PU-08-010

Product Update Hendrickson Load Scale Kits

Load Scale Kits

LIT NO: P56040

**Current 25,000 lbs
Gauge Face Plate**

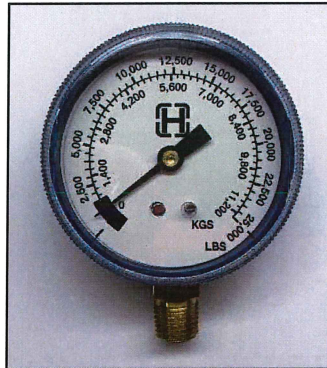
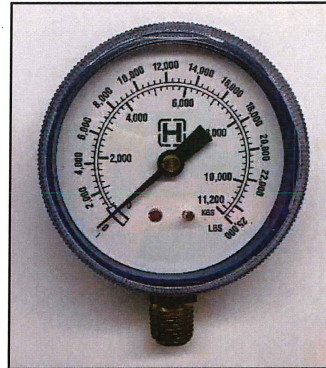
Fit and function of the new gauges remain the same. However, form is slightly different. Visually, the font used on the face plate is different and three of the gauges use different increments than their predecessor (*see image below*). These changes are scheduled to take effect with shipments starting in mid-June 2017.

**New 25,000 lbs
Gauge Face Plate**
